TOP DRAWING -  
REPAIR/MODIFICATION,  
GV S/N 506

| 59734     | A    | SE50000506 | B    |

This section defines and authorizes specific deviations encountered on aircraft serial number identified in this drawing's title. These are deviations noted while this aircraft was undergoing service repair or modification at Gulfstream Savannah Service Center.

CS262854.1. Discrepancy: Aircraft sustained a lightning strike and numerous entry/exit points have been noted.

REV. A cont.  
CS762854.1.2 & CS762854.1.3 Discrepancy cont.:

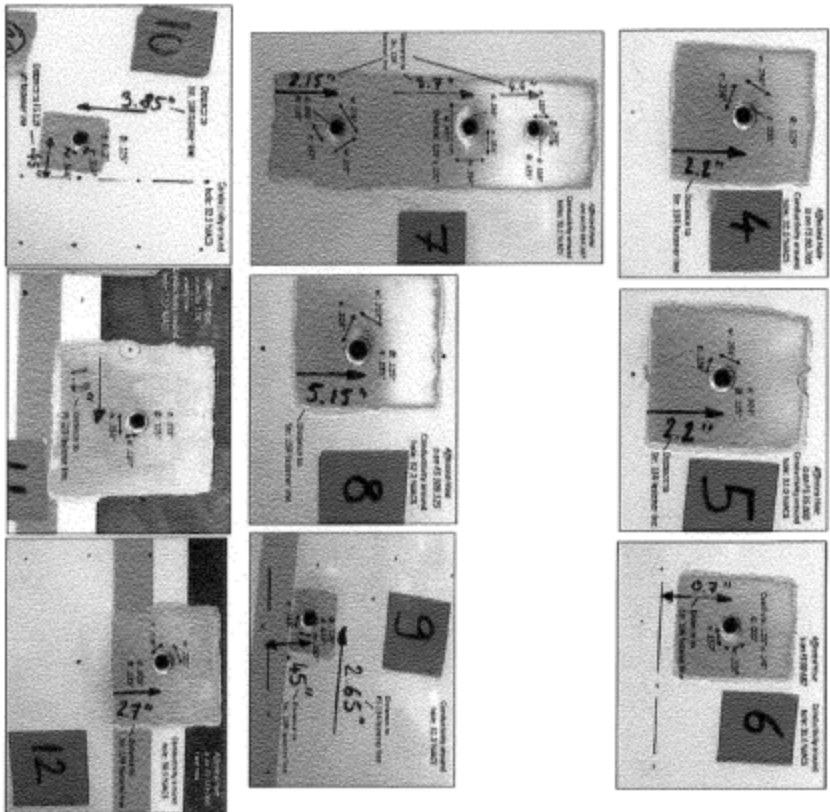
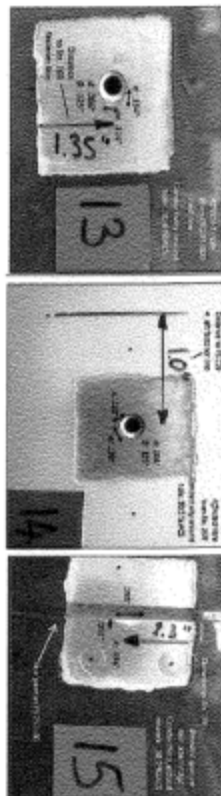
CS262854.1.2 & CS262854.1.3 Discrepancy: AOG Customer has complied with the prelim disposition and provided details.

CS262854.1.2.1 Preliminary Engineering Disposition: FOR AREAS: # 1, #2, #3, #4, #6, #7, & #8

PLEASE MEASURE THE FASTENER PITCH (CENTER-TO-CENTER HOLE DISTANCE) TO THE ADJACENT FASTENER ABOVE AND TO THE ADJACENT FASTENER BELOW THE DISCREPANT HOLE. IF THERE IS AN ADJACENT FASTENER FORWARD OR AFT OF THE SUBJECT HOLE, PLEASE PROVIDE THE FASTENER PITCH FOR THOSE ALSO. MEASUREMENTS PROVIDED SHOULD BE TO .XX INCH MINIMUM DECIMAL PLACE ACCURACY. RESUBMIT RESULTS FOR FURTHER DISPOSITIONING.

FOR AREAS: # 3 LOWER HOLE ONLY, #5, #9, #10, #11, #12, #13, & #14

THAT WERE DISPOSITIONED PREVIOUSLY, IF THE HOLES HAVE NOT BEEN COUNTERSUNK, LIMIT COUNTERSINK TO .240 INCH DIA. AND AFTER INSTALLING THE NAS1097AD5 RIVET, SHAVE HEAD FLUSH. THE HORIZONTAL TIPCAP IS ACCEPTABLE AS IS FOR CONTINUED NORMAL OPERATION. TOUCH-UP FIN 213 3012 AND PAINT TO CUSTOMER REQUIREMENTS.

CS262854.1.3.1 Engineering Disposition for AREAS #4, 6, & 8:

AT NOTED LOCATIONS INSTALL FREEZE PLUGS PER SE05102901-1. KEEP FREEZE PLUG HOLES TO A MINIMUM SIZE TO CLEAN OUT DAMAGE WHILE SATISFYING ALL REPAIR DRAWING REQUIREMENTS. AREAS 4 AND 8 SHOULD HAVE A .453 DIA. HOLE WITH A .490-.500 DIA. CSK. AREAS 6 SHOULD BE A .281 DIA. HOLE WITH A .320-.330 DIA. CSK.
